## ADDENDUM NO. 2

### TO: PLANS AND SPECIFICATIONS FOR STATE OF MISSOURI

**Hillsboro Treatment Center,  
Renovation to Interior,  
Core Building  
10434 State Road BB  
Hillsboro, MO 63050  
PROJECT NO. H2503-01**

A-102

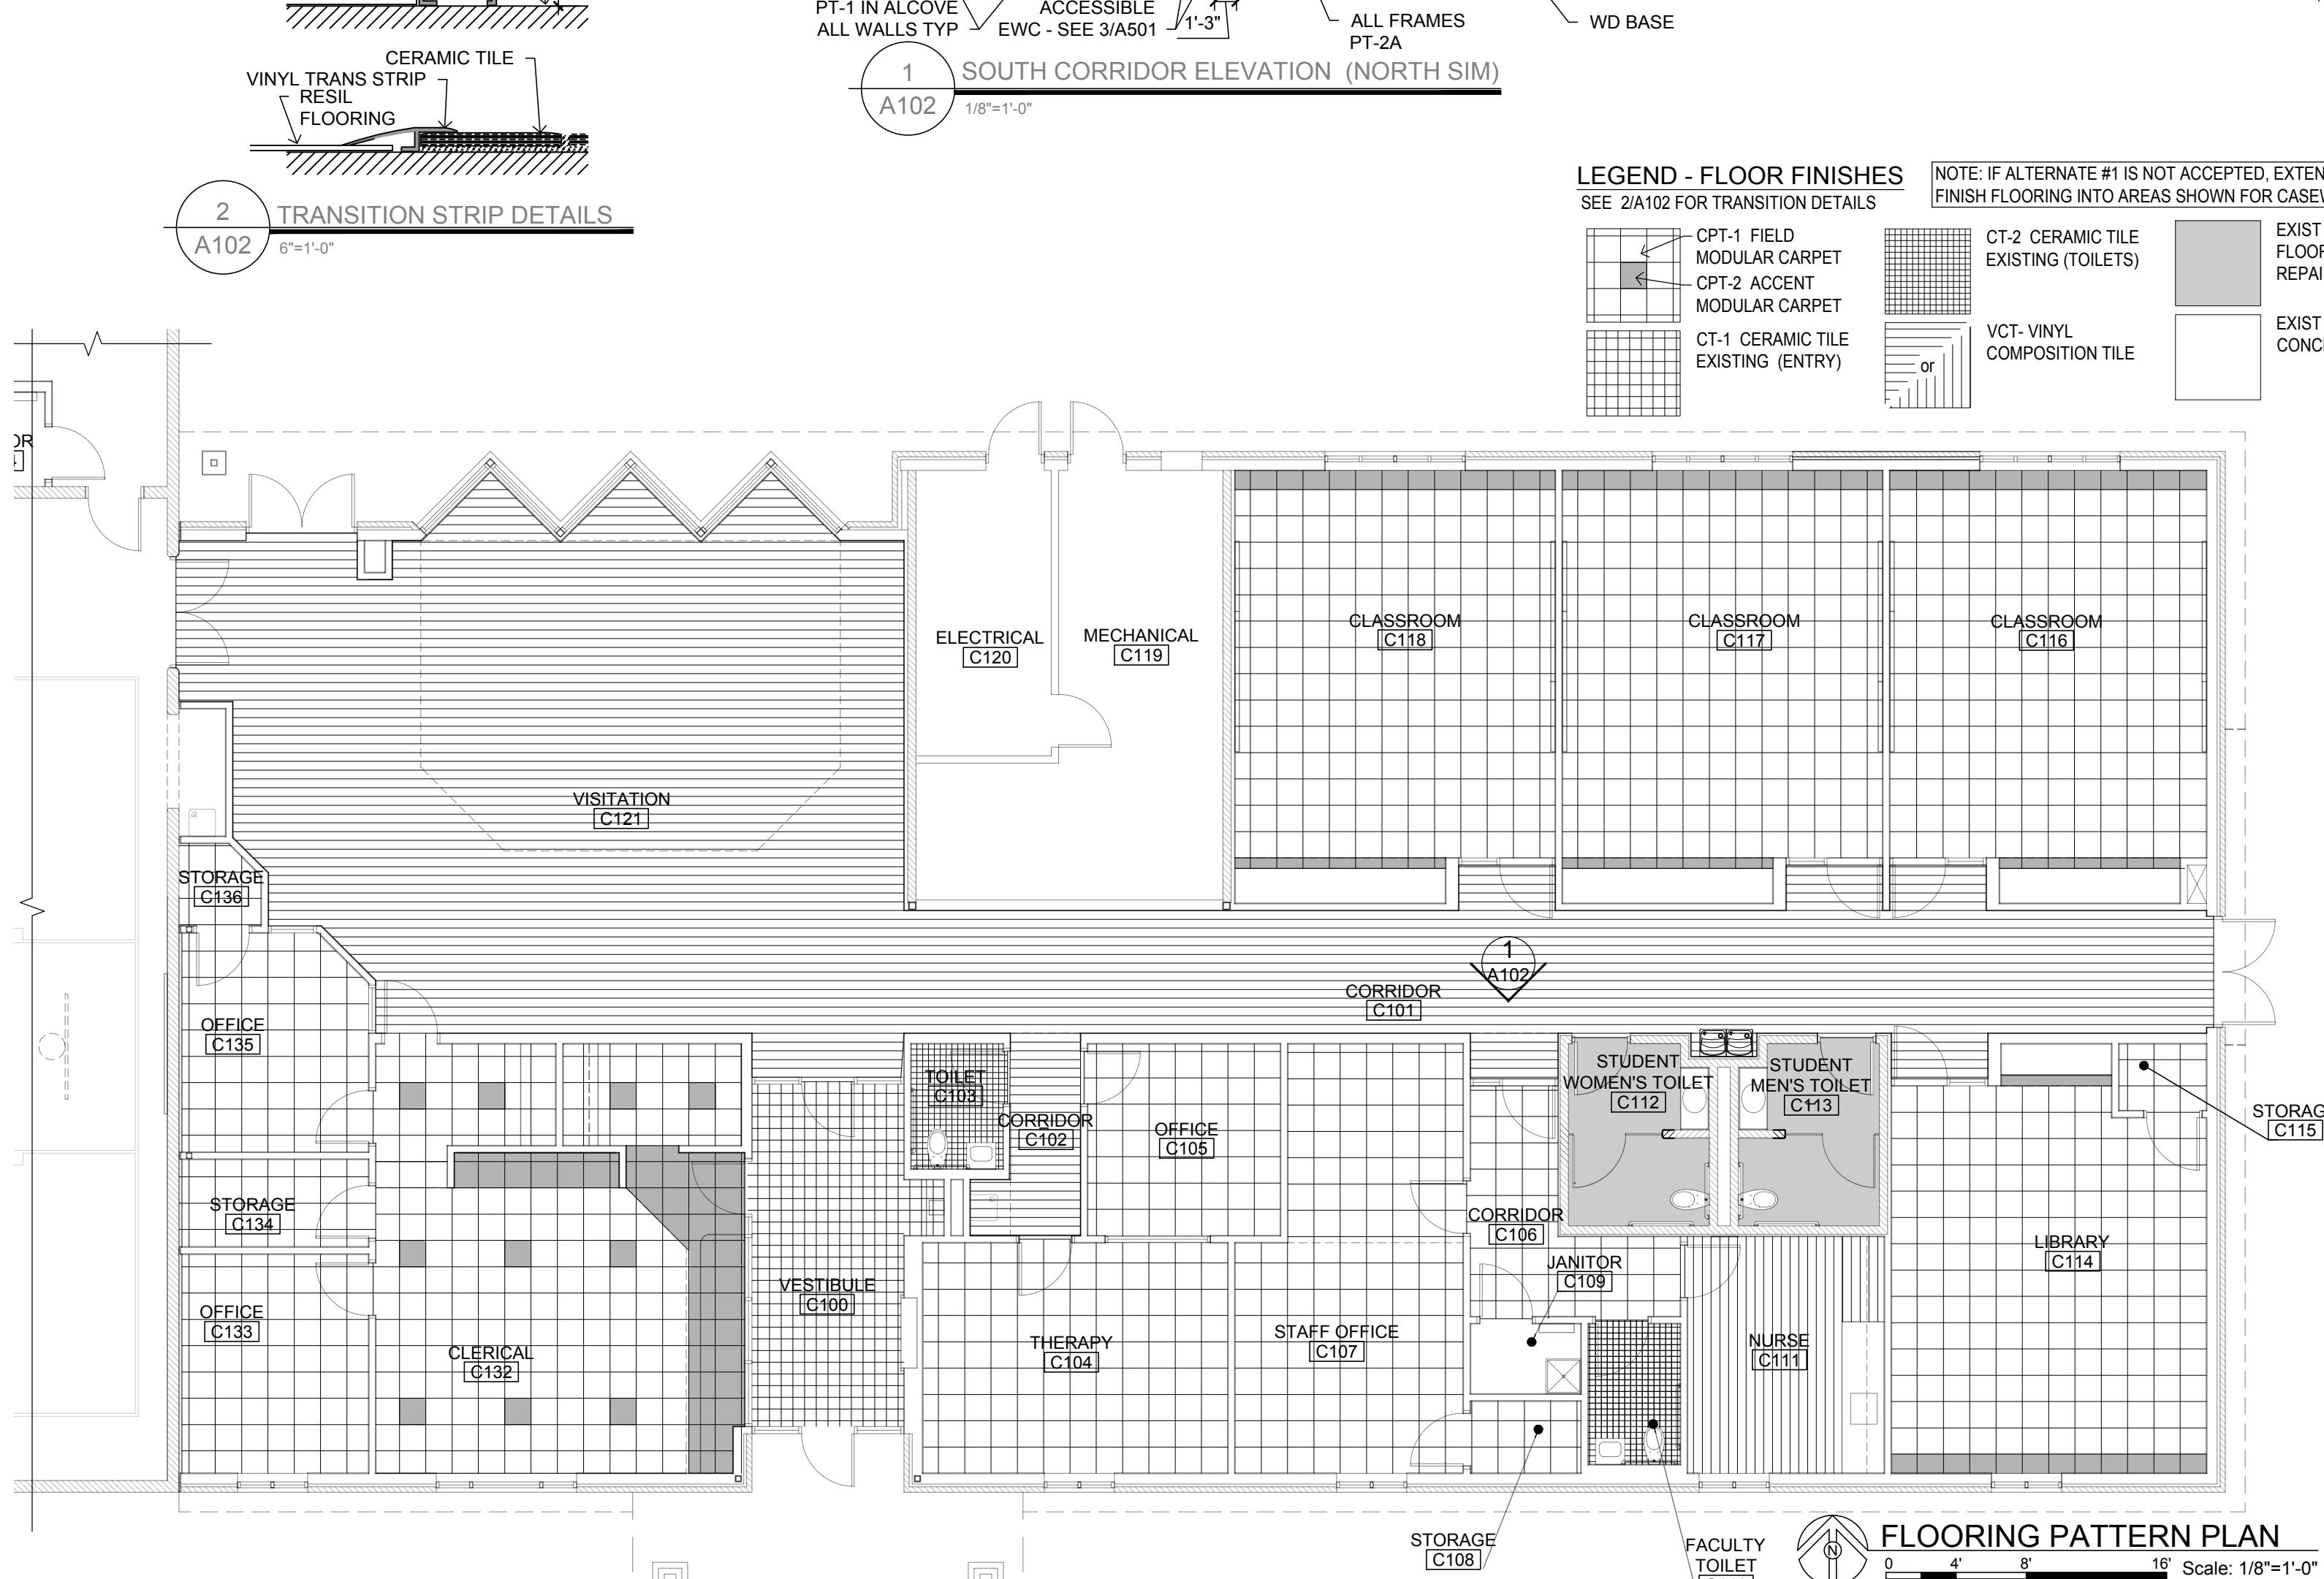
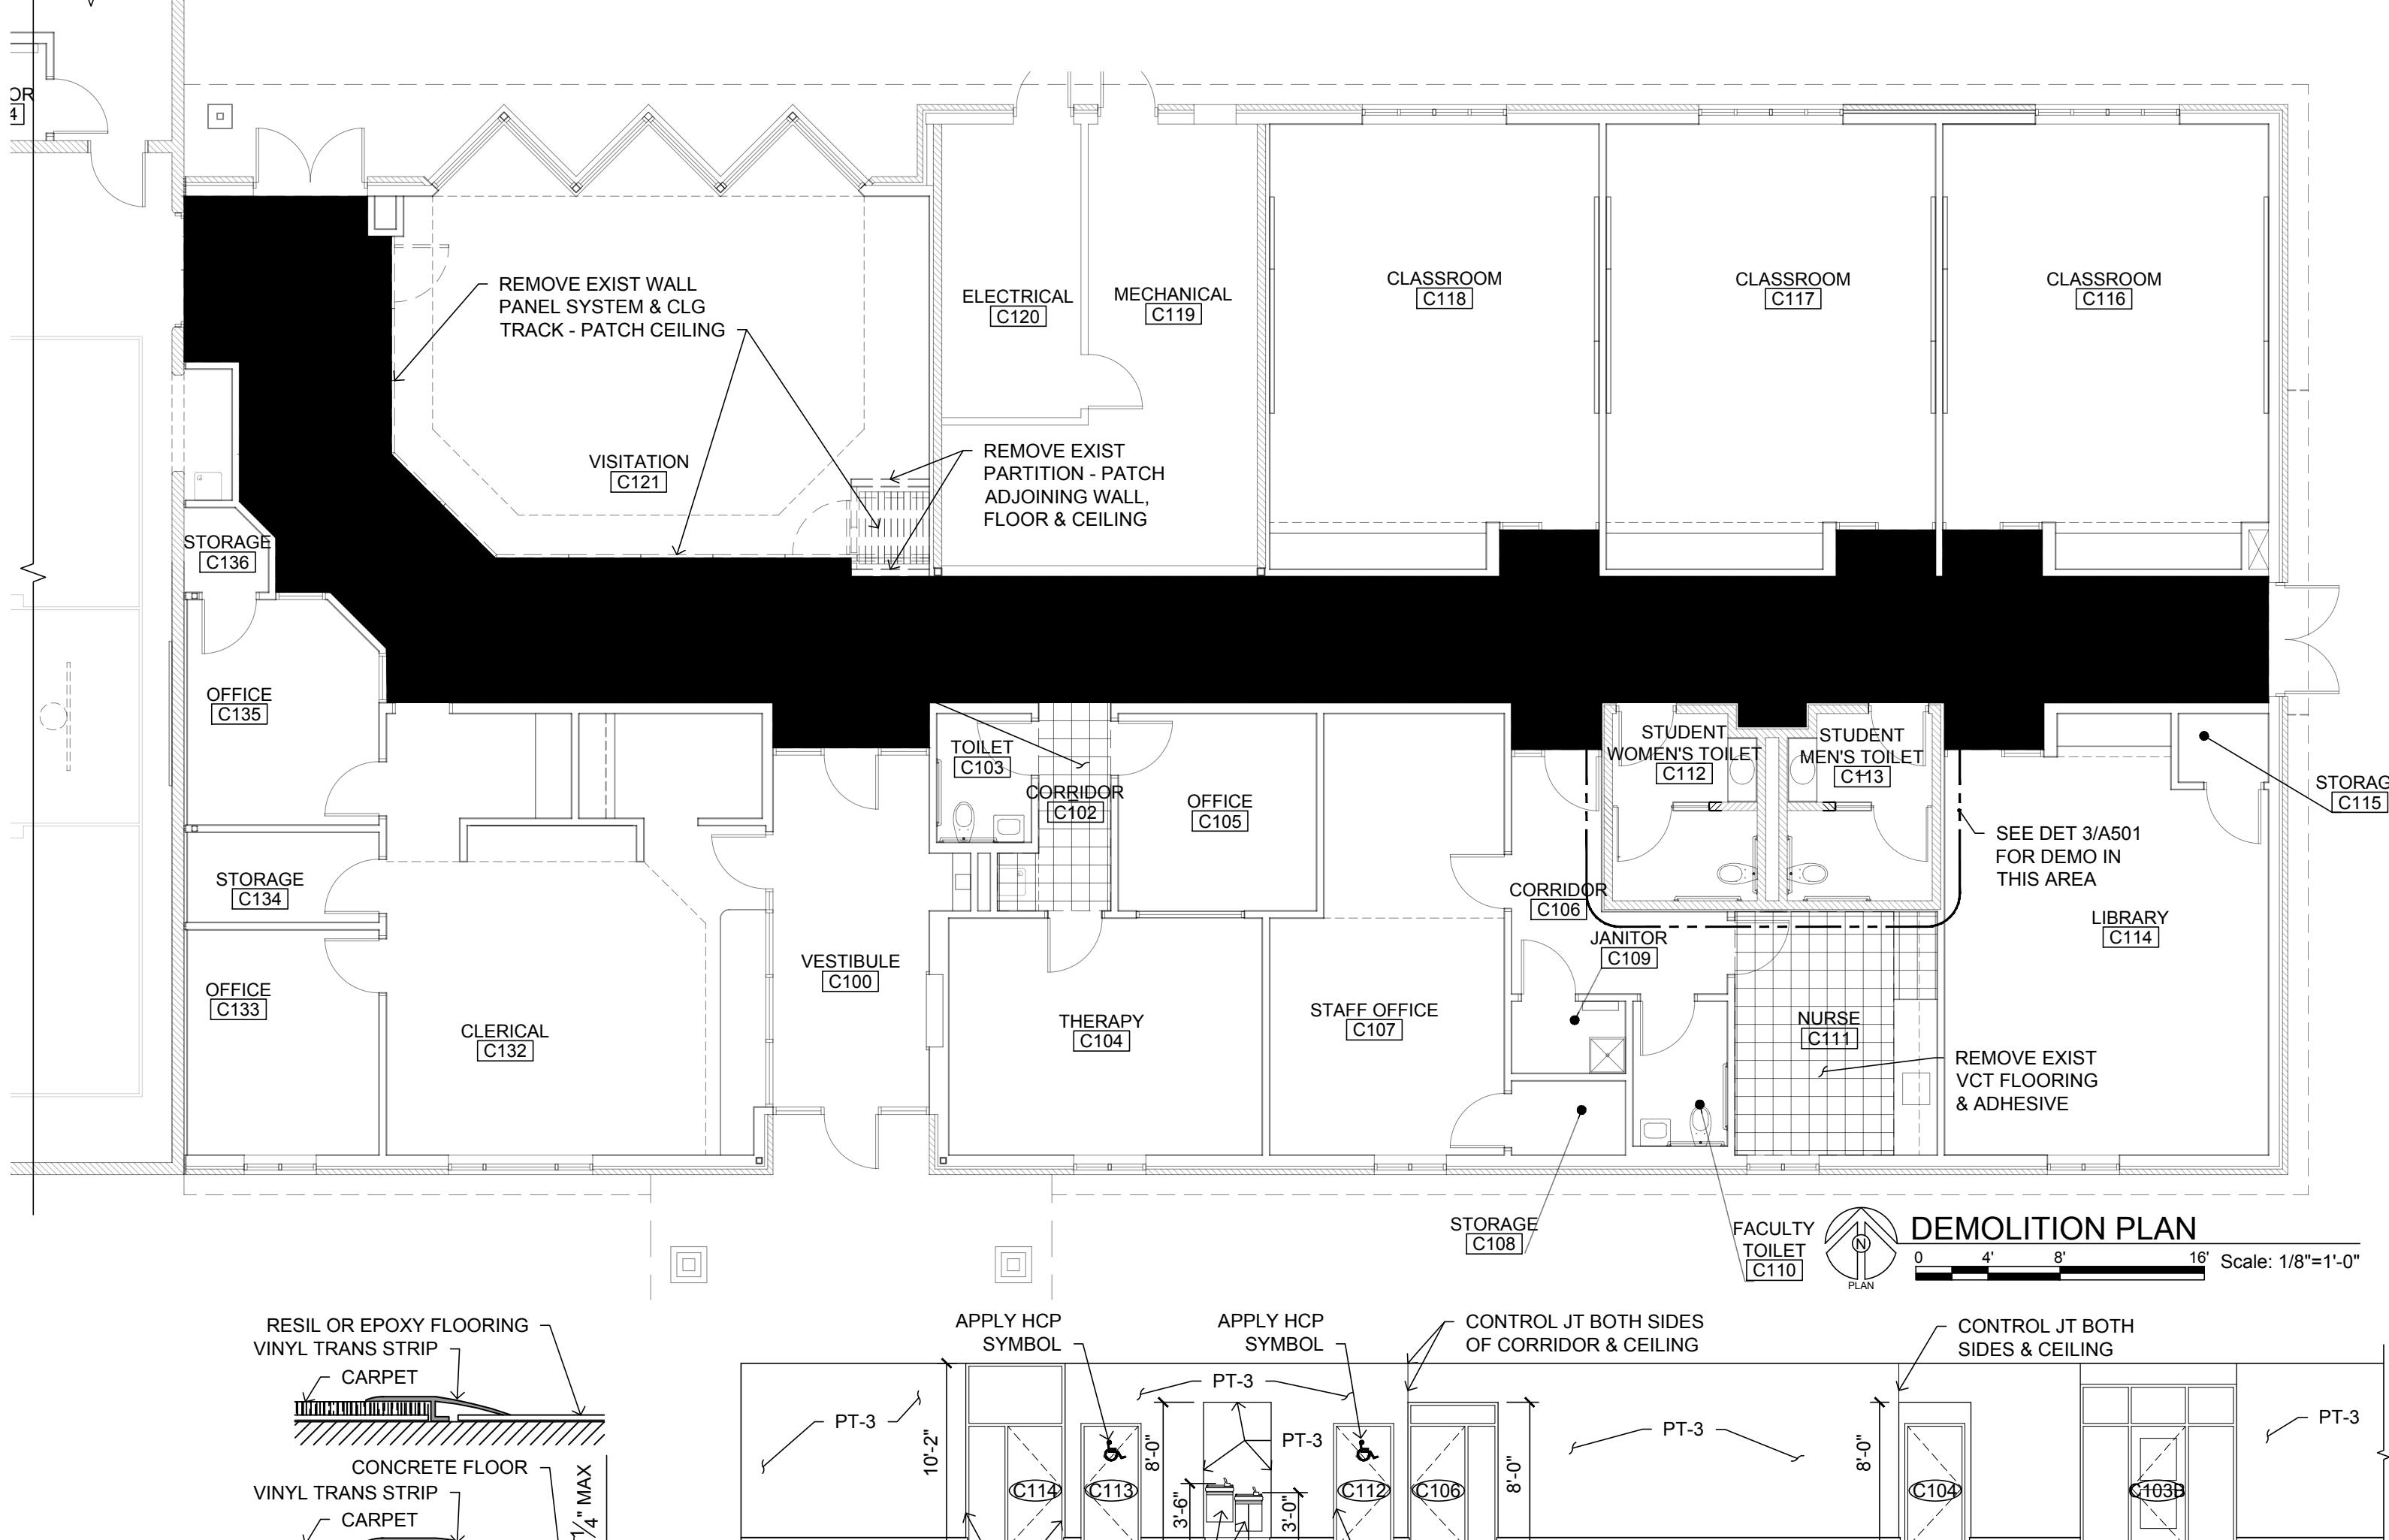
##### Sheet A-102

- a. On the Room Finish Schedule, in the CEILING/FINISH column replace all instances of "ASC" with "PT-7A."
- b. On the KEY TO FINISHES table, delete the following line in its' entirety: ASC | ACOUSTICAL SPRAY CEILING | SEE SPECS.

4. REPAIR ANY DAMAGED FINISH ON PREFINISHED DOORS – REFINISH AS REQUIRED.
2. There is a note about acoustical spray ceiling to match existing, it looked like everything was a smooth finish. Please advise on how we are supposed to finish the ceilings.

Response: *See Sheet A-102 Drawing Changes noted above.*
